Log # TXX-91076
File # 910.4
10110
Ref. # 10CFR50.55(e)

March 22, 1991

SUBJECT: COMANCHE PEAK STEAM ELECTRIC STATION (CPSEG)
DOCKET NOS. 50-445 AND 50-446
AUXILIARY FEEDWATER SYSTEM CHECK VALVES
SDAR CP-89-015 (SUPPLEMENTAL REPORT)

SIDE VIEW OF BWIP CHECK VALVE

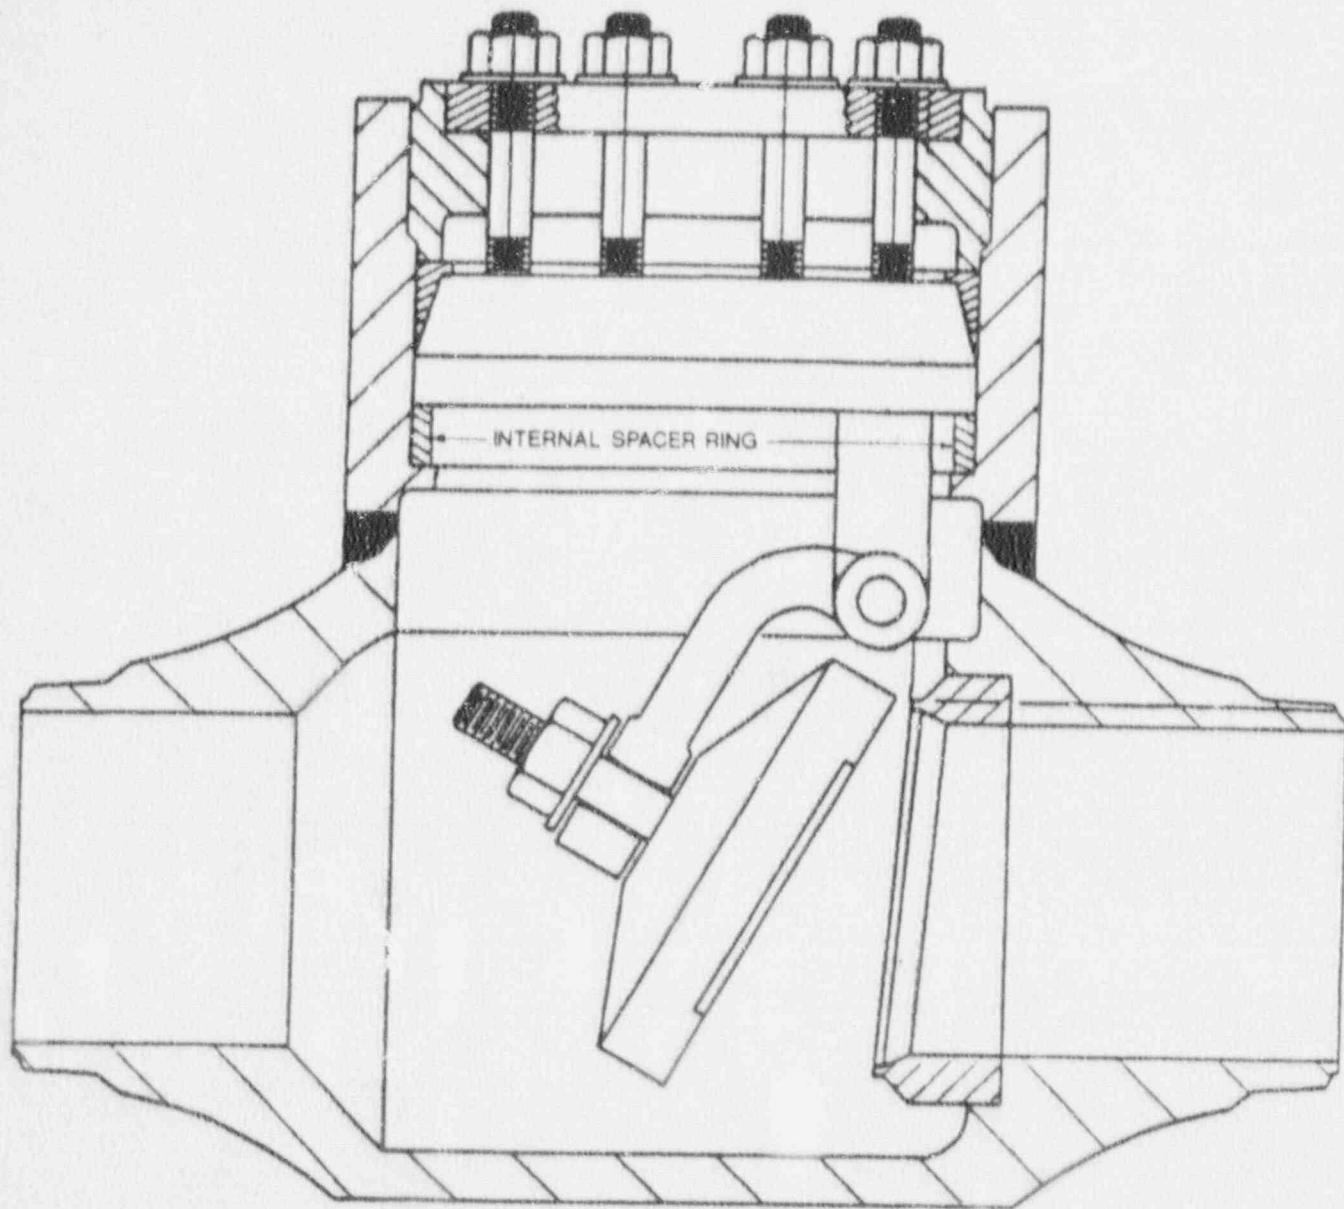
To simplify the reassembly process, a modification will be made to the BWIP pressure seal check valves. This modification consists of an internal spacer ring and an external alignment device (see enclosed drawings). The internal spacer ring positions the bonnet assembly at the height required for correct disc contact on the seat. Each valve is measured, a spacer ring is machined to the required dimensions, and the spacer ring is welded in place.

The external alignment device consists of an alignment block welded to the top of the valve body and an alignment bar welded to the valve bonnet (see enclosed drawings). When the valve is reassembled, the alignment bar fits into the alignment block, preventing axial misalignment of the disc.
